LC 73

2019 Integrated Resource Plan.

Reply Comments of  
Renewable Northwest

December 17, 2019

- Hypothetical 100 MW Wind Resource
- Same wind resource, with different deliverable scenarios

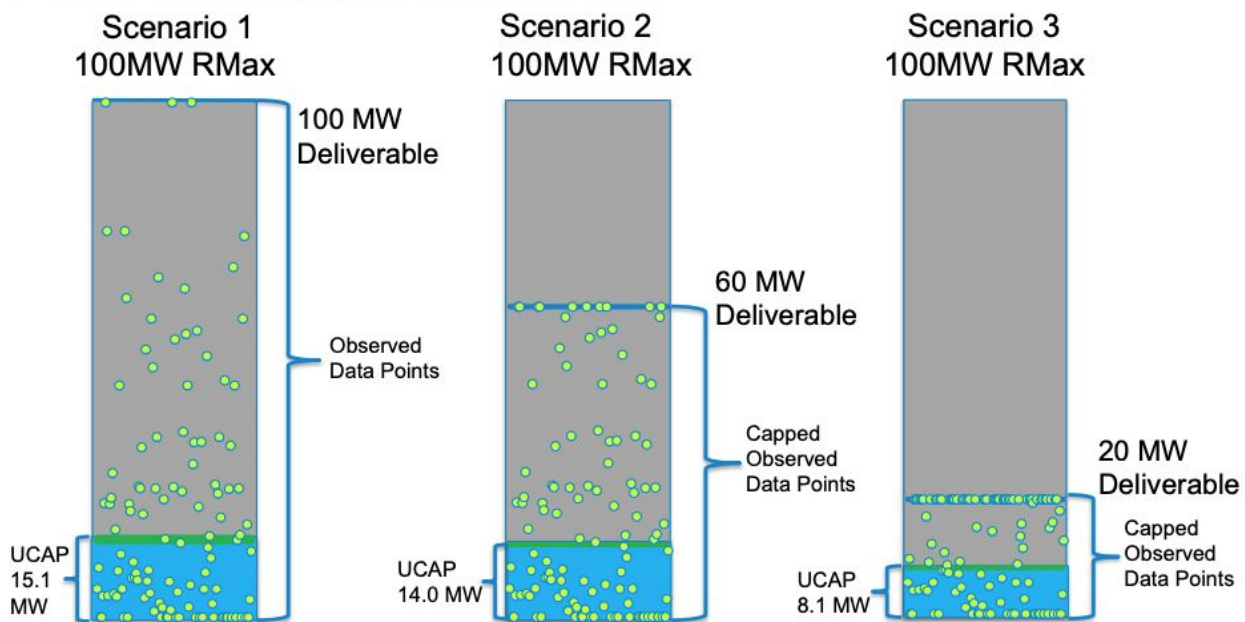
We encourage PGE to explore whether reducing the level of maximum output for which it would require long-term transmission may be warranted. As we noted above, the capacity contribution of a VER is generally below the resource’s ICAP value. Additionally, deliverability using firm transmission service may have diminishing returns. We offer an example of analysis done by Midwest Independent System Operator (“MISO”) as it is considering the level of firm transmission service it will require to ensure deliverability of resources that are relied on for their capacity contribution towards resource adequacy requirements. As the graphic below shows, firm transmission service at 60% of ICAP for a wind resource has a minimal negative impact on the capacity contribution of the resource, as compared to the capacity contribution when the resource has firm transmission service for 100% of ICAP.<sup>9</sup>

In this analysis, the capacity contribution, represented by the Unforced Capacity (“UCAP”) value, is decreased from 15.1 % to 14% when the firm transmission available to ensure deliverability of this resource is decreased from 100% to 60% of the ICAP. Capacity contribution of the resource with 80% firm transmission service would likely be very close to that at 100% firm transmission. We encourage PGE to explore whether 80% of maximum output over long-term transmission is optimal for VERs and what the impacts on a resource’s capacity contribution may be if PGE were to require lower levels. If PGE does not adopt this suggestion for a 2020 renewables request for proposals (“RFP”), we encourage PGE to explicitly identify this issue as one to explore for future renewable RFPs within the 5 years framework for the Interim Transmission Solution.
